Hatch Spent Fuel Pool Modification  
Amendment 2

Response to NRC questions contained in the NRC's letter of August 24, 1979

RESPONSE TO NRC QUESTIONS  
CONTAINED IN THE NRC'S  
LETTER OF AUGUST 24, 1979

Figure 7-2 Storage Cell Dimensions

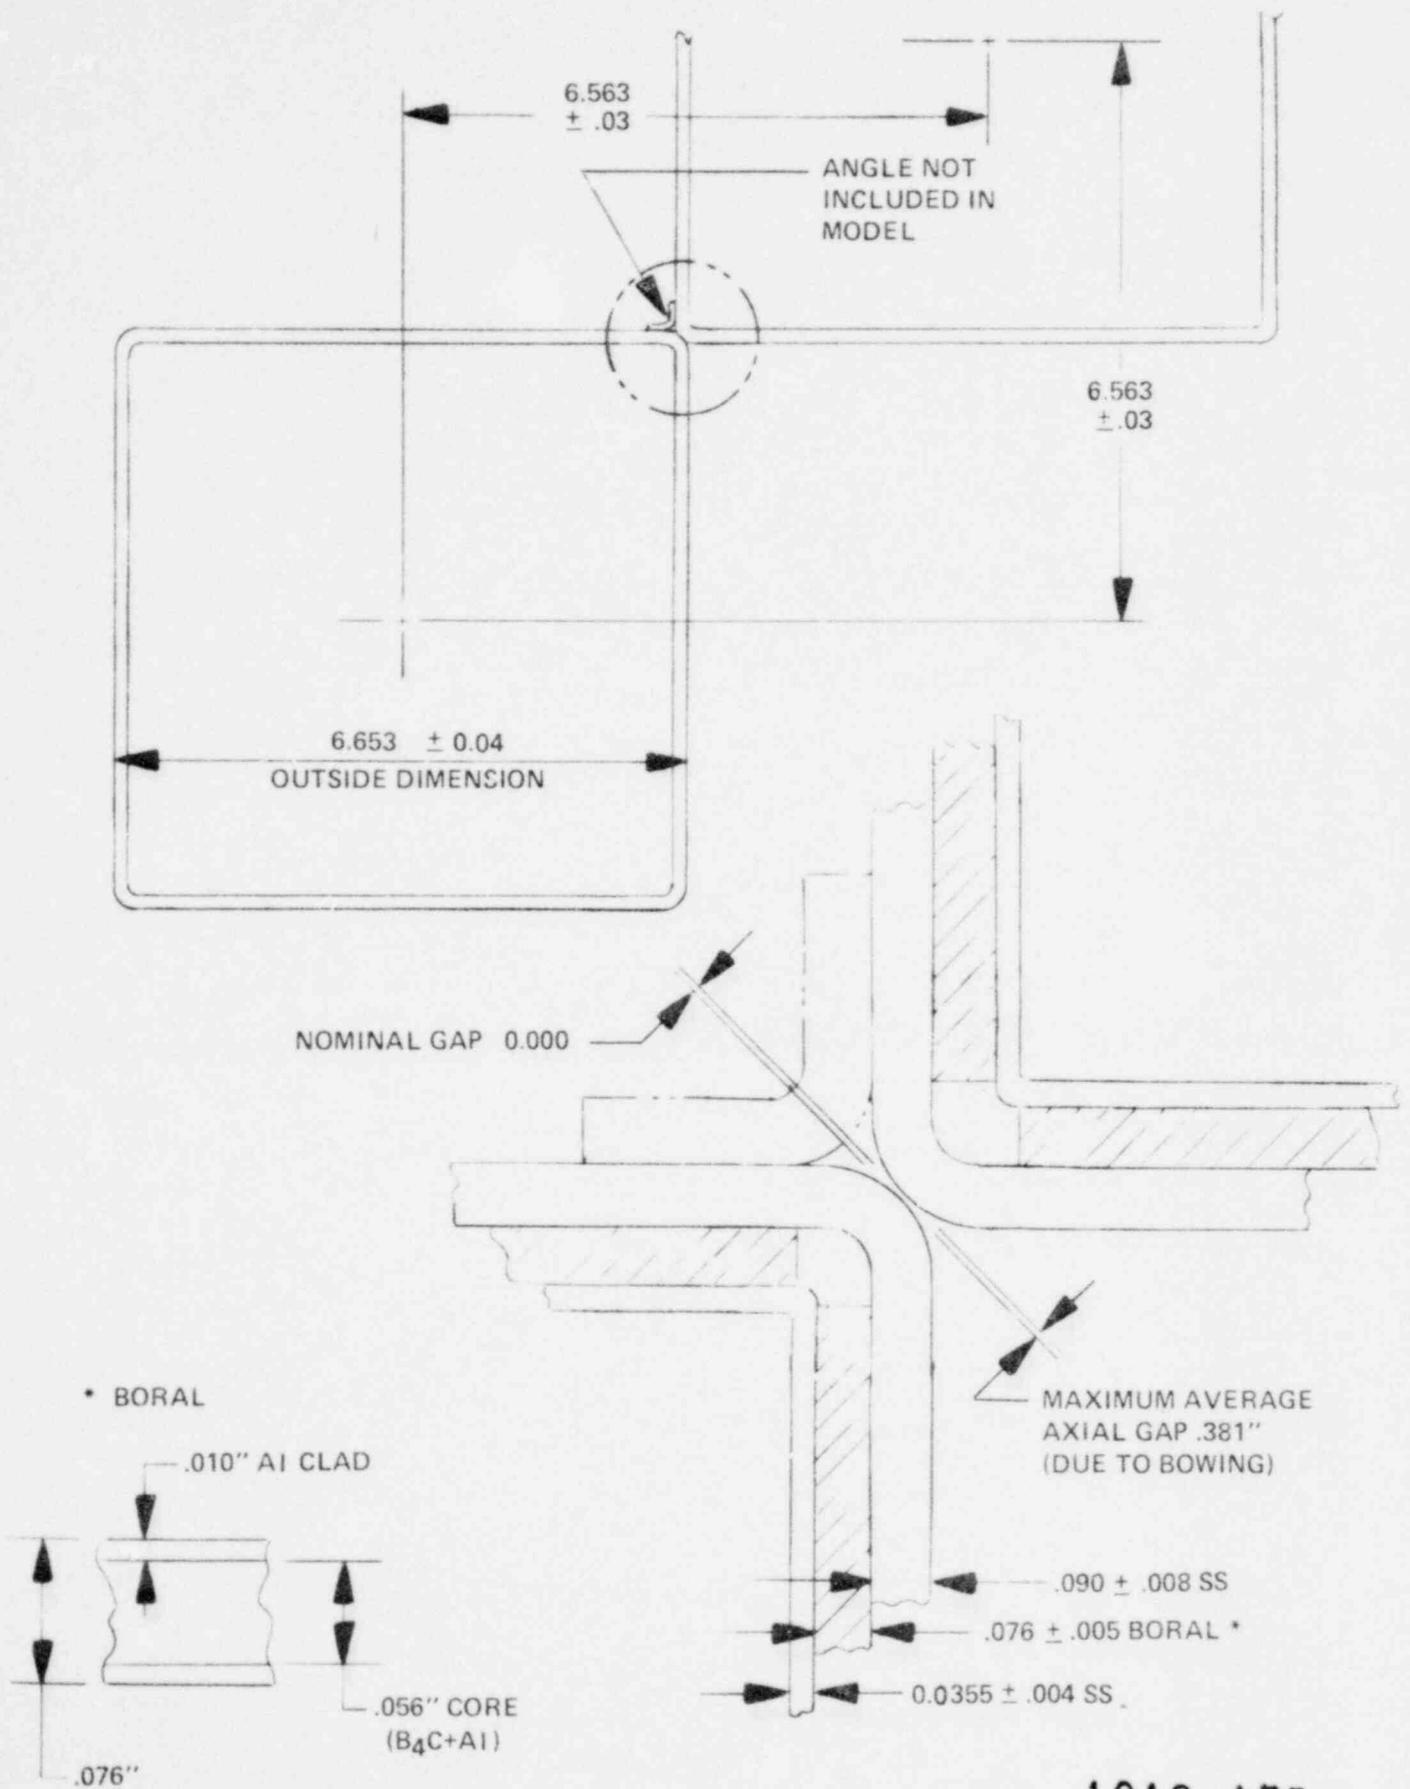
On page 7-3 of your submittal you state, "The results in Table 7-1 show that the nominal pitch (Case 2) has a higher  $k_{\infty}$  result than the minimum pitch case (Case 6)." Since the statistical error bounds given on Table 7-1 do not preclude the opposite conclusion, and since all other calculations for similar storage lattices show the opposite to be true, provide a justification for this conclusion.

- d. Storage lattice pitch - An analysis was done using a minimum fuel pitch, represented by the storage tubes touching. Material tolerances in the tubes were taken to maximize the  $k_{\infty}$  of the storage lattice. The result of the analysis is given as Case 6 in Table 7-1. A comparison of Cases 2 and 6 in Table 7-1 shows that within the statistical error bounds there is no significant difference between the results.

Item d. on page 7-3 has been restated to correct this discrepancy.
